Thank you for purchasing the flash memory programmer PG-FP5.

This document describes specifications that have been added or changed, restrictions, and cautions on using the PG-FP5. Also see the user's manual of the PG-FP5 for cautions on using the PG-FP5.

Chapter 2 Additions and Changes to Specifications

No. 1 Modification of **Cancel** button specification

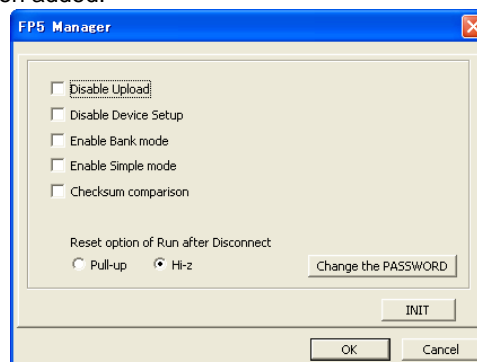
Description: The function of the **Cancel** button on the PG-FP5 main unit has been modified so that cancellation, which was applied to all commands, is only applied to the **Read** command.

Implementation: This item has been implemented in products with control code A (firmware: V1.01, FPGA: V1, GUI: V1.00).

No. 15 Addition of **Wide Voltage mode** function

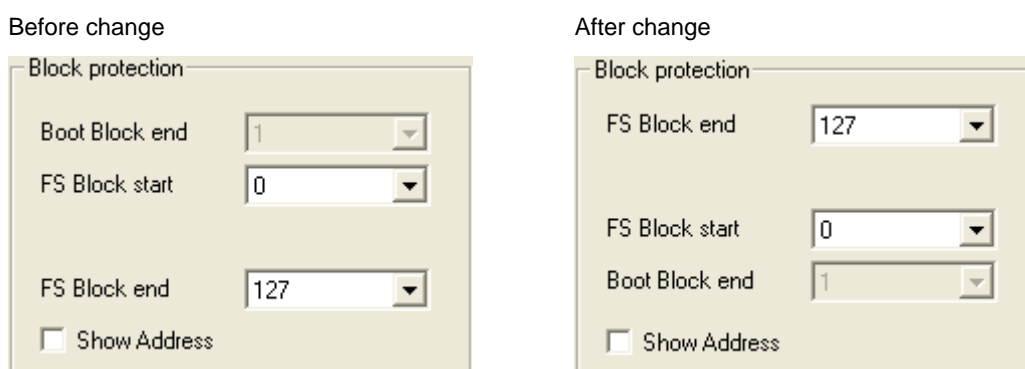
Description: The **Wide Voltage mode** check box has been added to the **Command options** area.

If this check box is selected, commands are executed in the wide voltage mode. If this check box is not selected, commands are executed in the full-speed mode. This check box is available when a device supporting this function is selected. For details about the wide voltage mode and full-speed mode, see the user's manual of each device.

Implementation: This item has been implemented in products with control code A (firmware: V2.02, FPGA: V2, GUI: V2.02).

No. 26 Writing to 78K0 microcontrollers by using an external UART clock

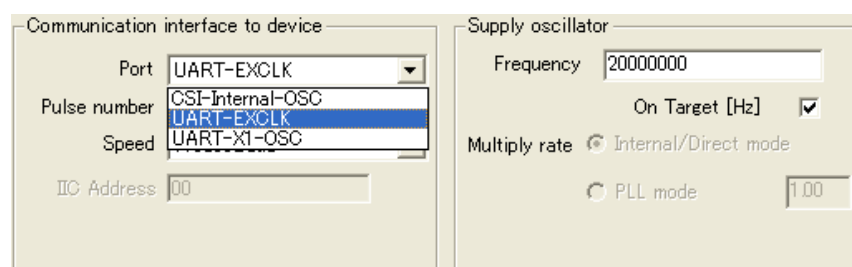
Description: When writing to 78K0 microcontrollers by using UART communication, the PG-FP5 can now perform writing to a target system in which an external clock is input to the microcontroller's EXCLK pin. To enable this feature, select **UART-EXCLK** in the **Port** list box, select the **On Target** check box, and input the relevant frequency to the **Frequency** box.

Along with the addition of this feature, the options in the **Port** list box have been changed as follows:

UART-Ext-OSC → UART-X1-OSC (select when using an external resonator clock)

UART-Ext-QB2CLK → UART-EXCLK (select when using an external clock or the FP5 clock)

Implementation: This item has been implemented in products with control code A, C, D (firmware: V2.06, FPGA: V4, GUI: V2.06).
